Name of Proposed Subdivision Northshore Phase 2A

File No. 1984-1-FP

Re: Northshore, Phase 2-A
ROK 83205

Re: Northshore
Phase 2A
ROK 83205

1 OF 17

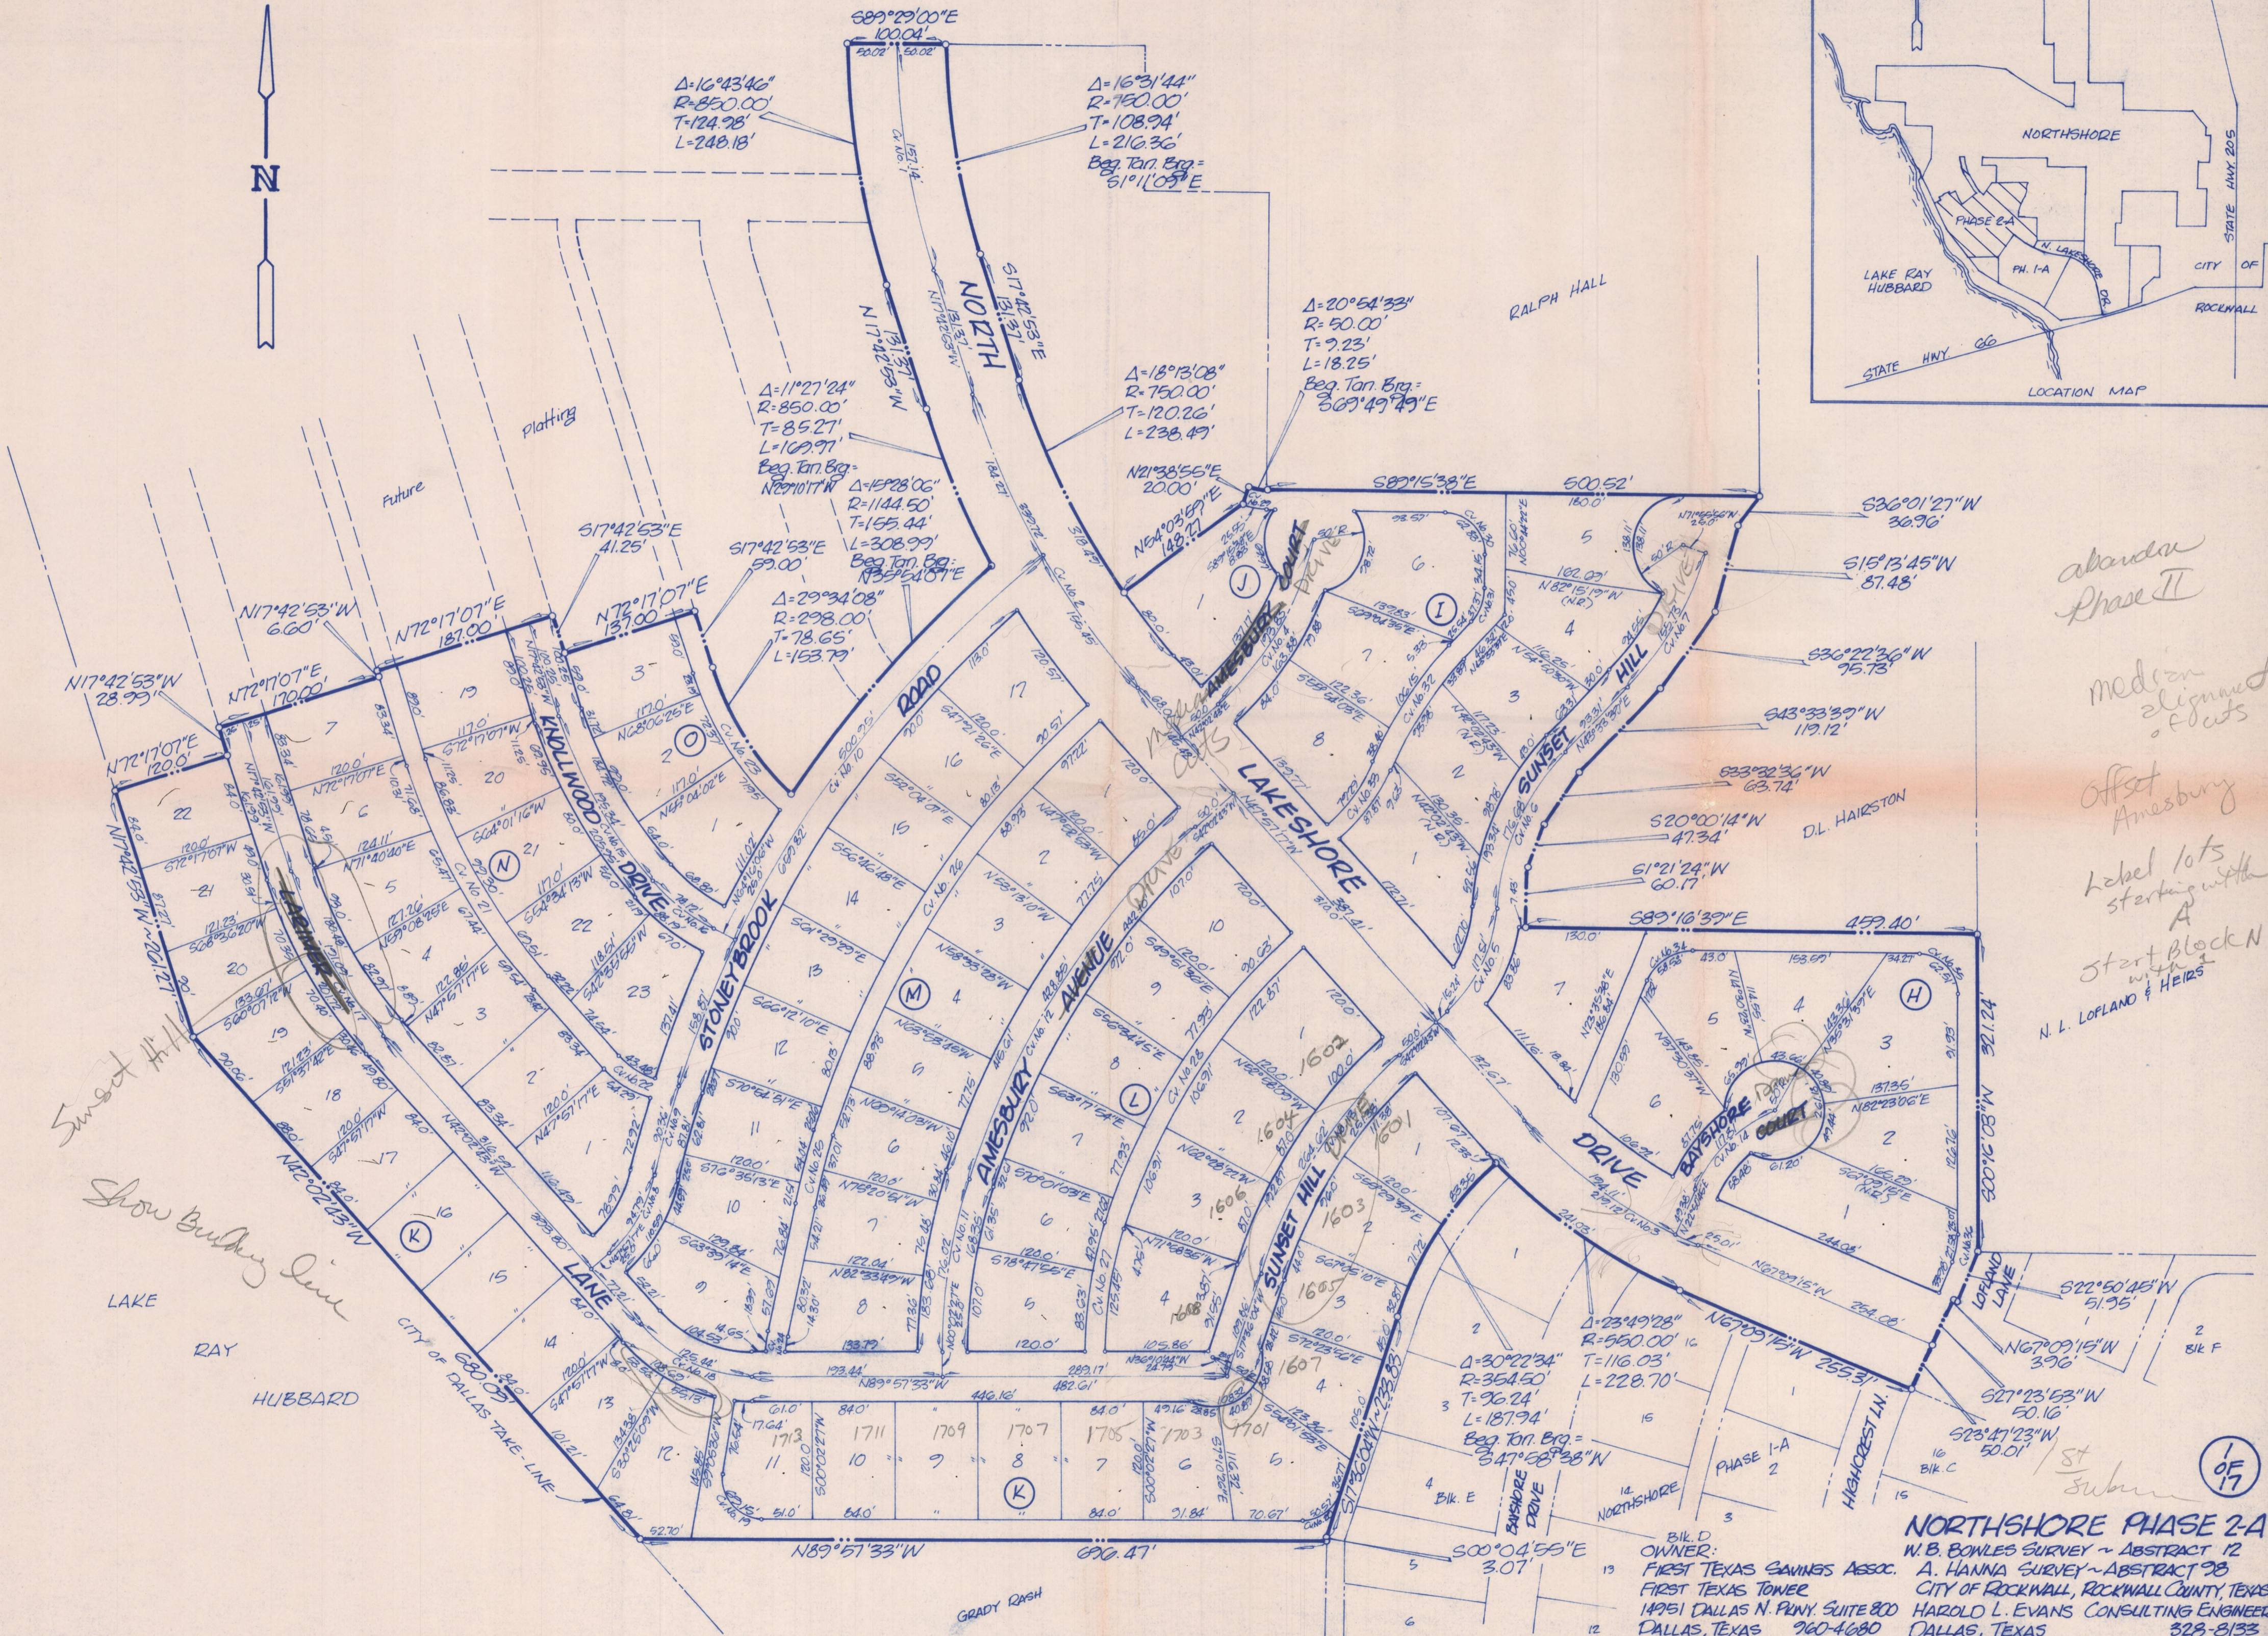
- Needs:
1. Block labeled starting with "A" and Lots with "1"
 2. Widen lot frontages on curves
 3. Name Larimer Lane Sunset Hill Drive
 4. Change Bayshore Court to Drive
 5. Change name of Amesbury Court
 6. Show building lines and easements
 7. Resubmit engineering for review of storm drainage and paving.
-

abandon Phase II
median alignment of lots
offset Amesbury
label lots starting with A
start Block N with N. L. LOFLAND & HEIRS

Sunset Hill
Show Building Line
LAKE RAY HUBBARD
CITY OF DALLAS TAKE-LINE
